NEW YORK HARBOR
CHANNEL NAVIGATION IMPROVEMENT 50 FT PROJECT
AMBROSE CHANNEL

CONTRACT2
S–AM–1
W912DS–05–B–0012

Symbol	Description	Date	App.
A	Revised Plan sheets No.3,4,5,6,8,9,10,11,12 and cross sections sheet No.13,14 and15	8/8/05	G.A.
B	Sheet C-33 and C-34 are eliminated and sheet numbers are renumbered accordingly 1 thru 35, and Alignment Data sheet All Plan Sheets and Cross sections sheets are revised.	7/19/05	G.A.

COVER SHEET,GENERAL PLAN AND INDEX TO DRAWINGS

CROSS SECTIONS STA.-24+00 TO STA.156+00

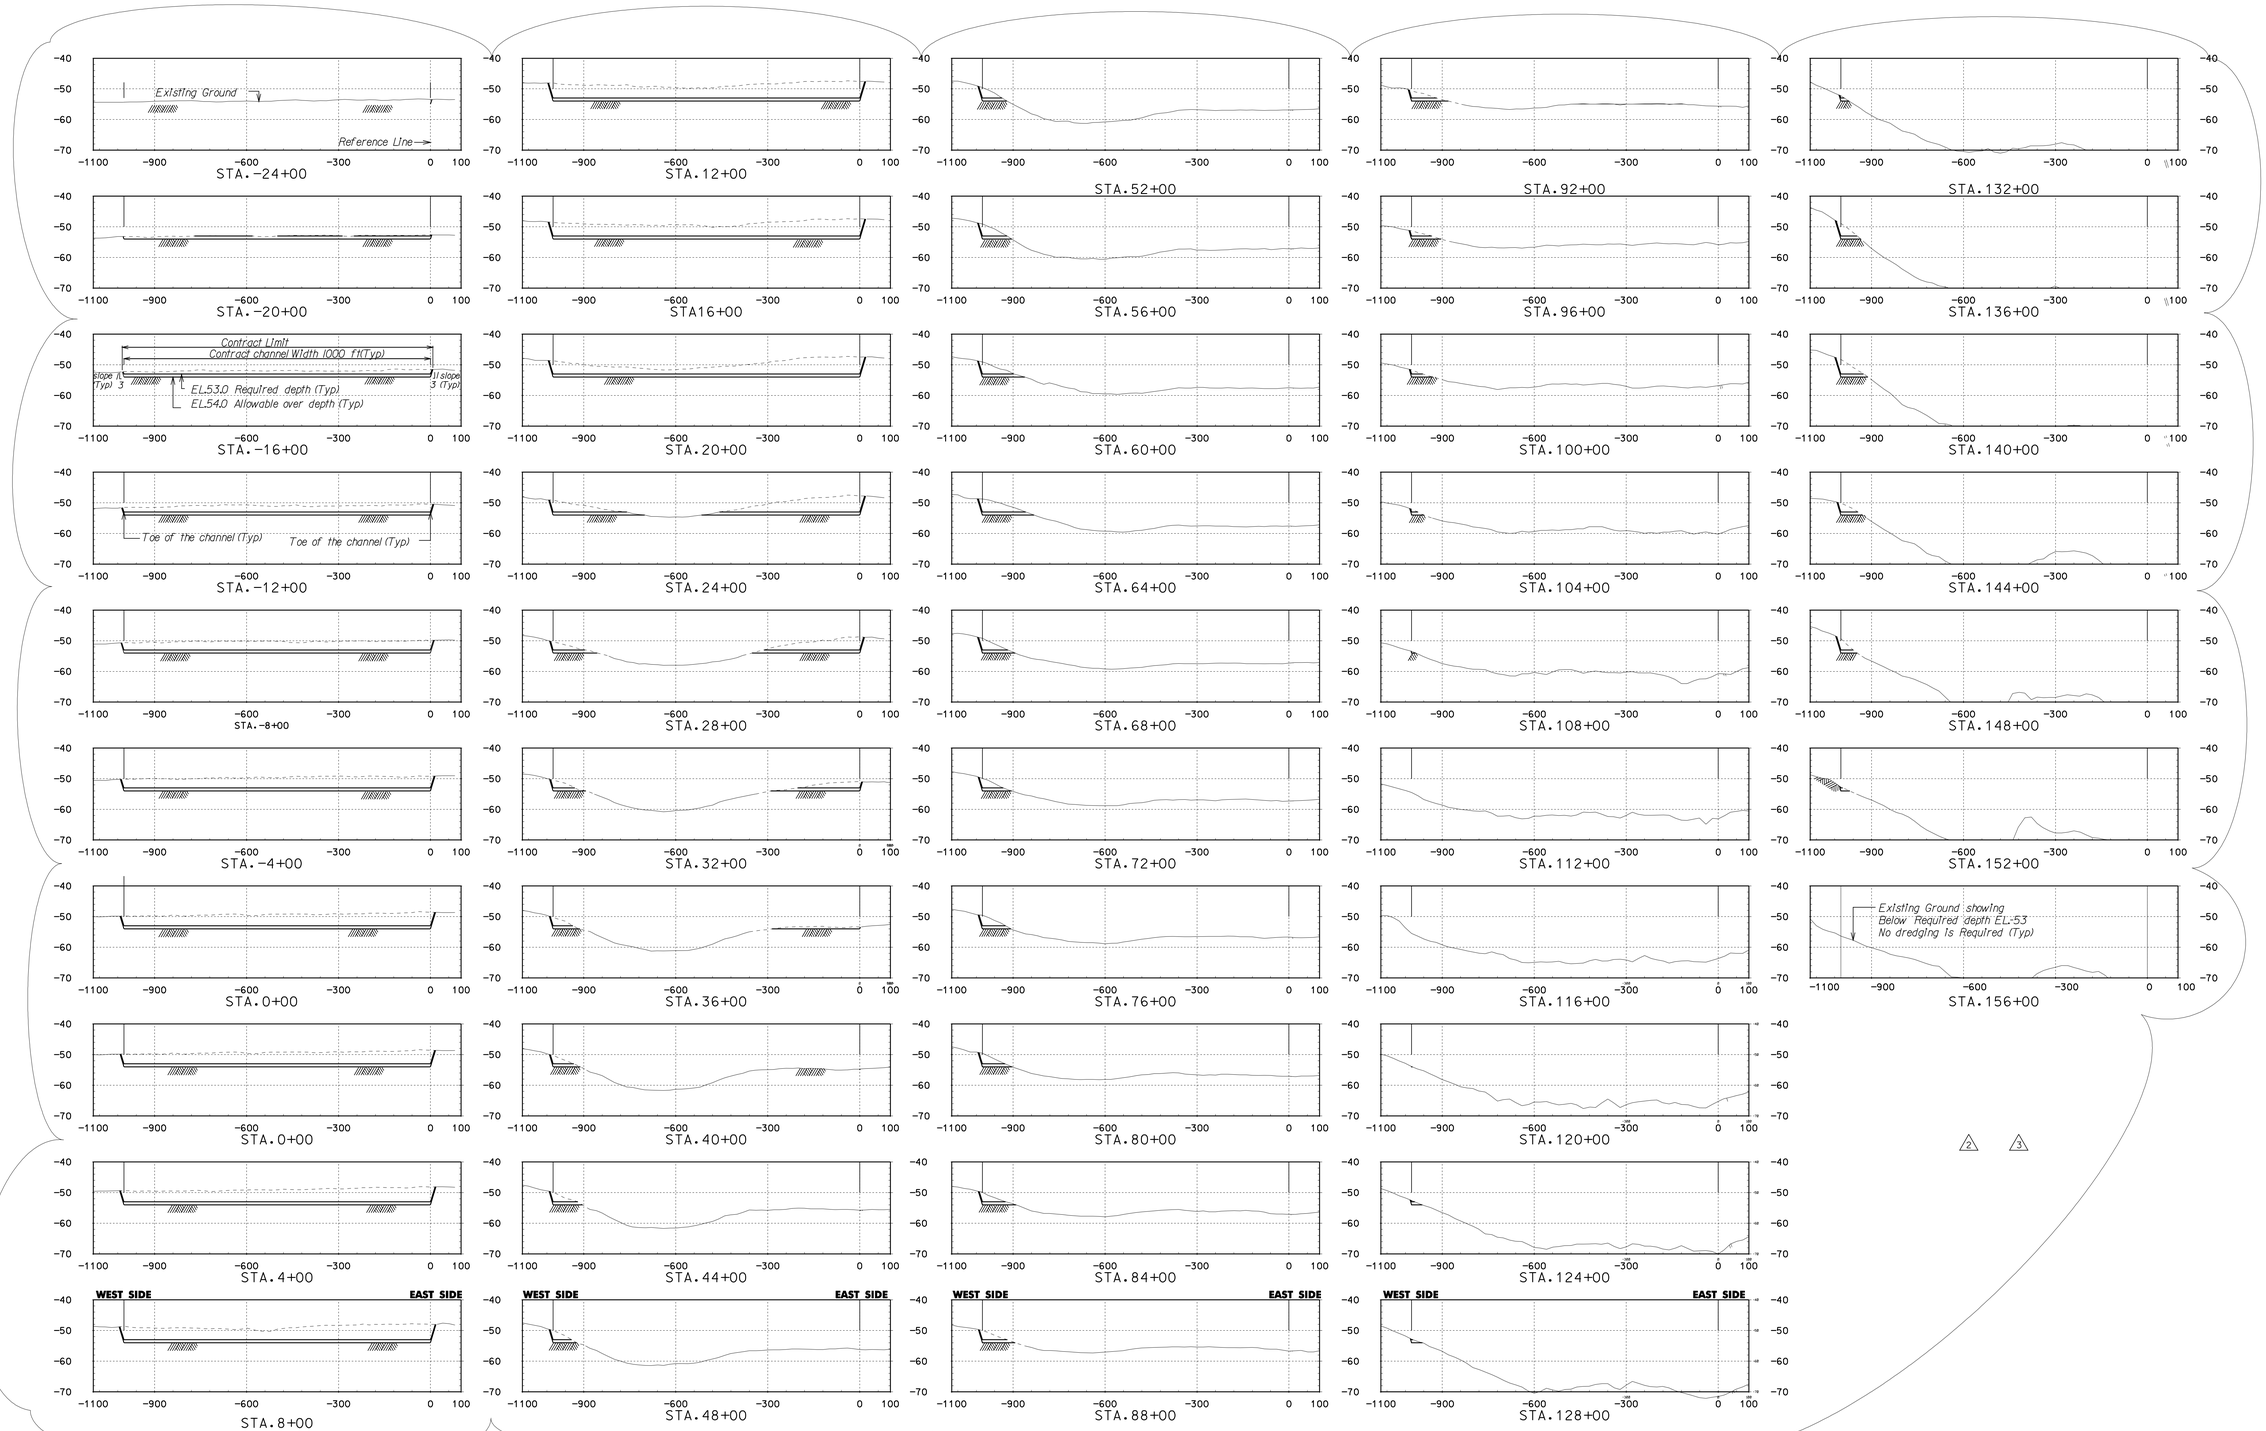
Rev.	Description	Date	Appr.
2	Allowable Overdepth is Revised to 1.5 ft and upgrad allowable 5 ft overdepth is eliminated.	7/19/06	G.A.
1	Allowable Overdepth is Revised to 1.5 ft overdepth is revised to EL-55.0	8/8/05	G.A.

CROSS SECTIONS STA336+00 TO STA484+00

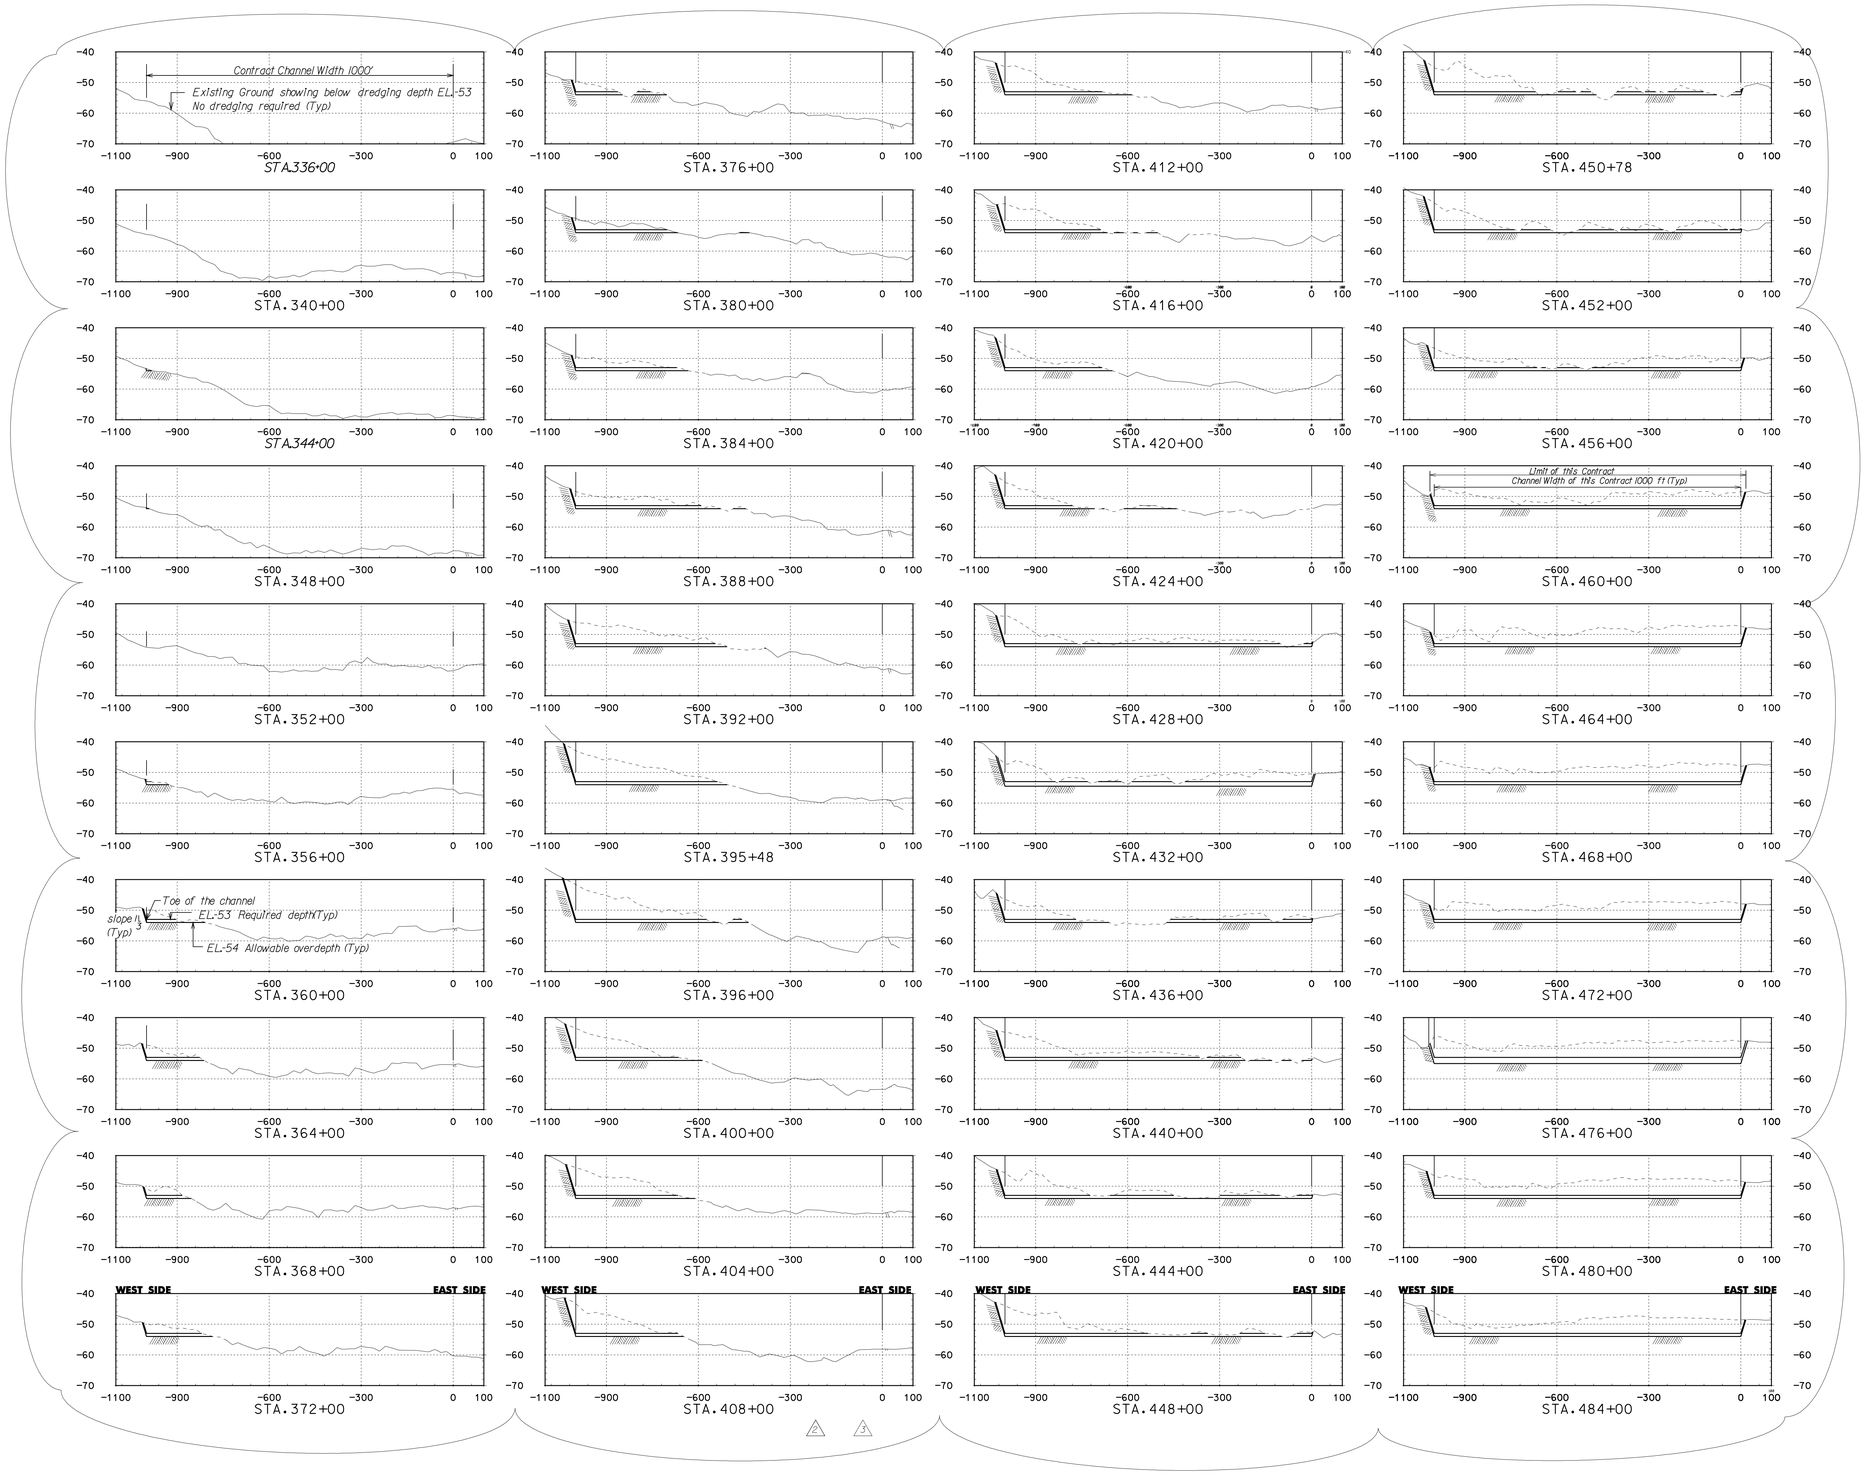
Symbol	Description	Date	Appr.
2	Allowable overdepth is Revised to EL-54 (typical maximum 5 ft) allowable overdepth is Eliminated.	8-10-05	G.A.
3	Allowable overdepth is Revised to EL-44.5 and (typical maximum 5 ft) allowable overdepth is revised to EL-55.0	1-19-06	G.A.

CROSS SECTIONS STA488+00 TO STA680+00

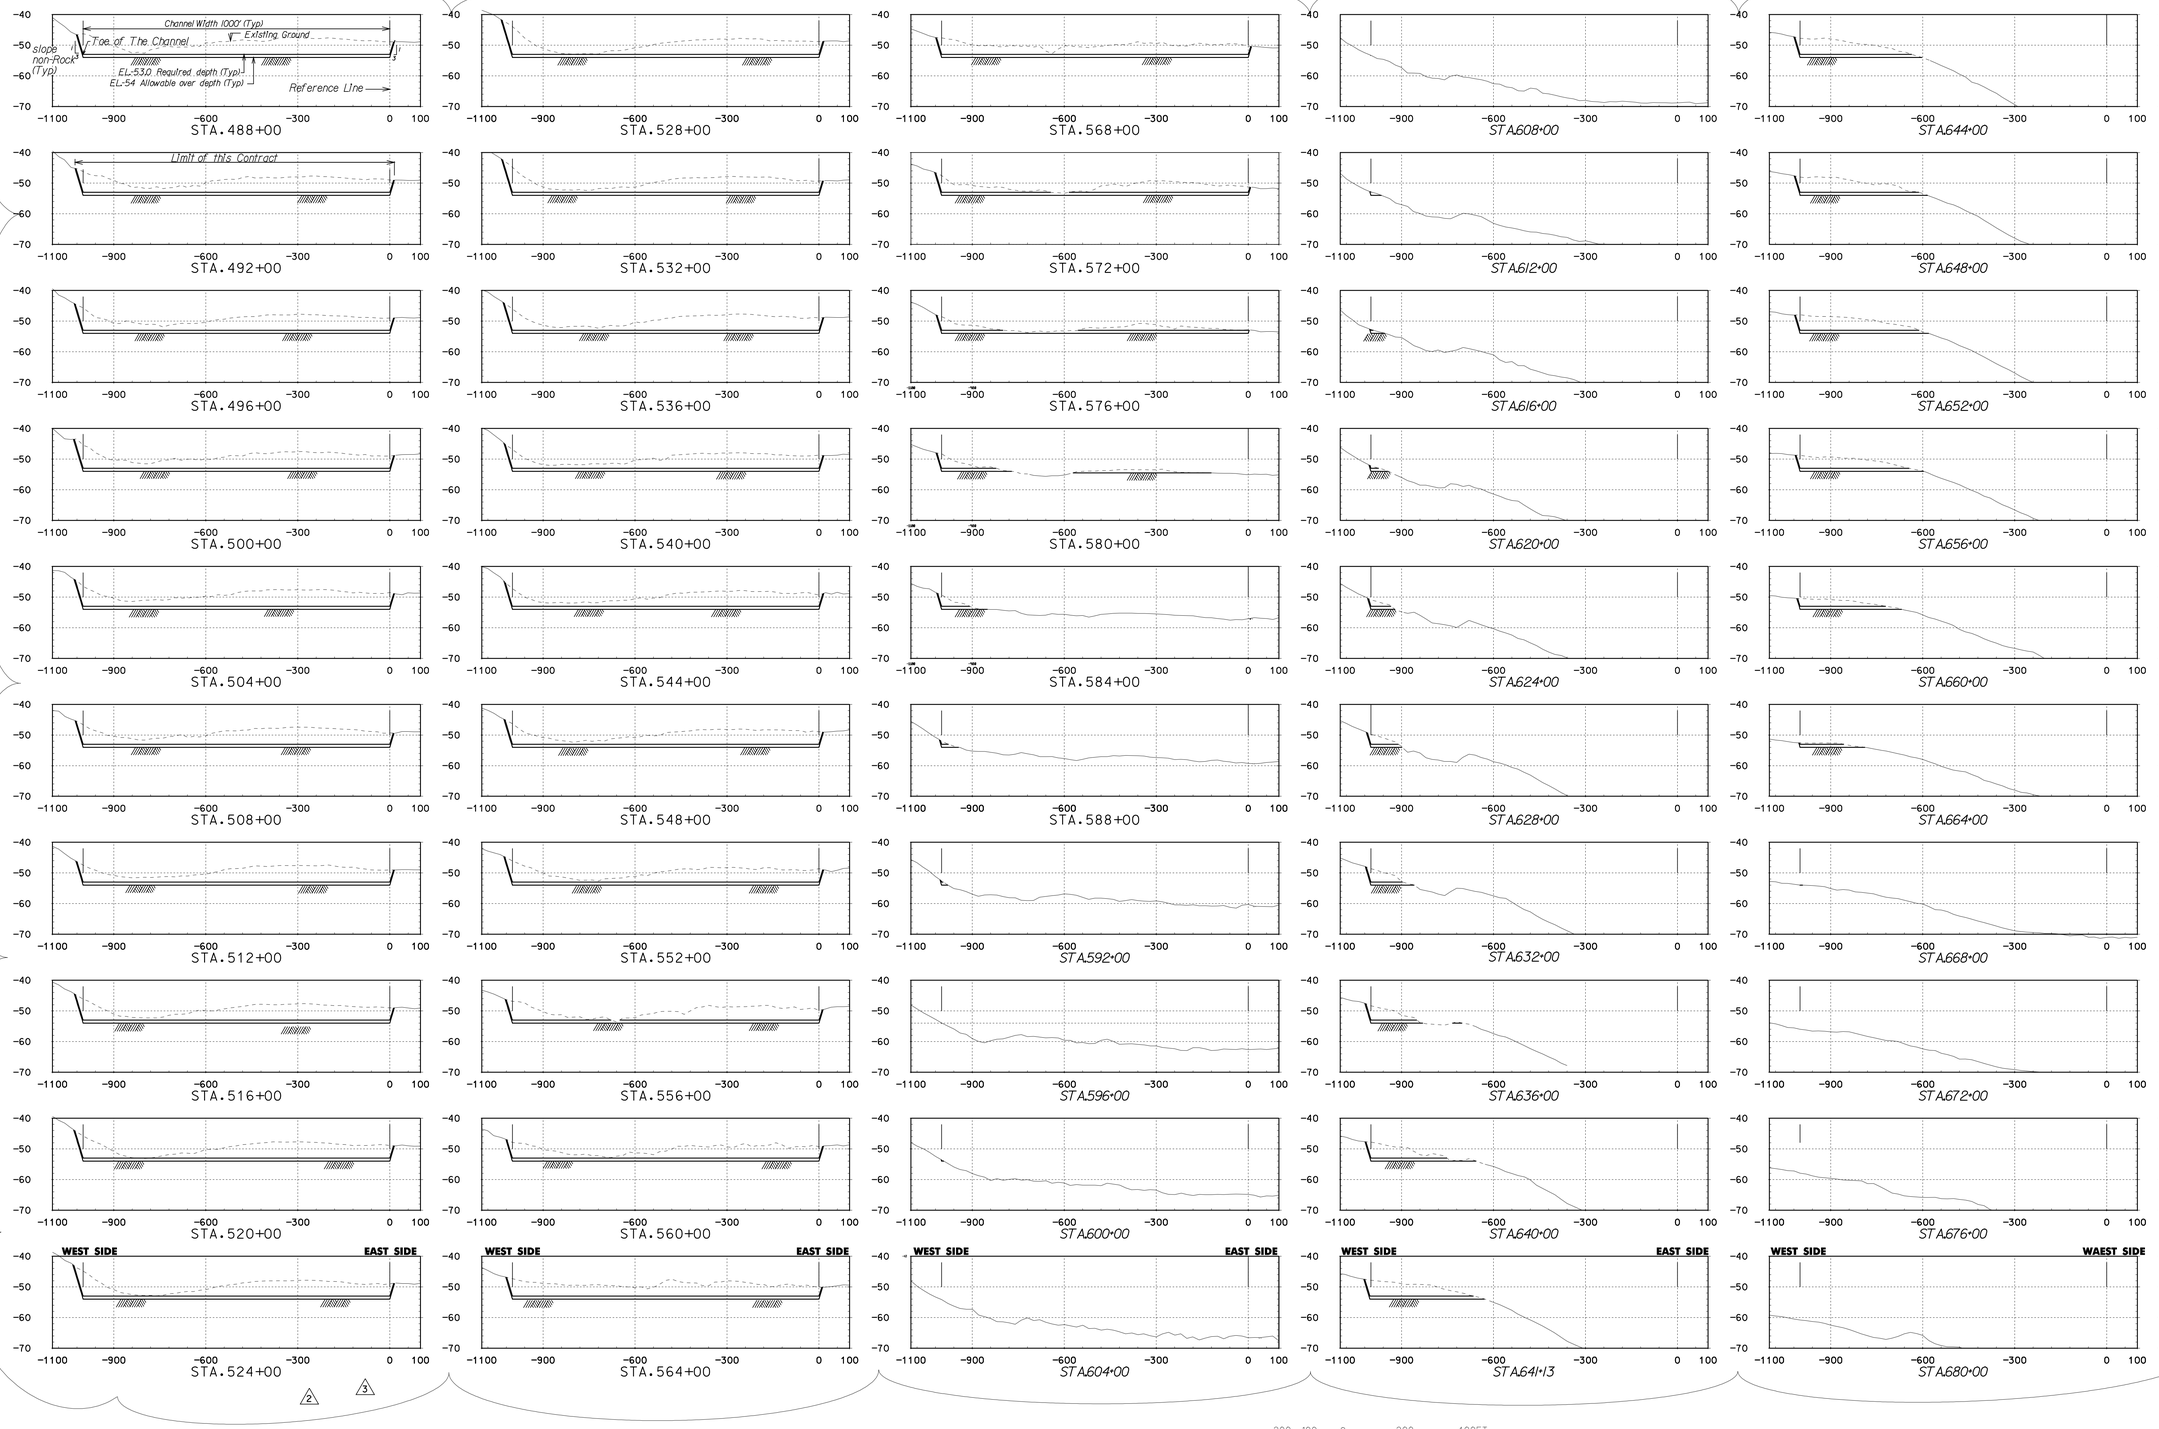
Description	Date	Appr.
2 Allowable overdepth is revised to EL-54 and Maximum L.S. Flowpoint allowable overdepth is eliminated.	8/8/05	G.A.
1 Allowable overdepth is revised to EL-54.5 and Maximum L.S. Flowpoint allowable overdepth is revised to EL-55.0	7/19/05	G.A.
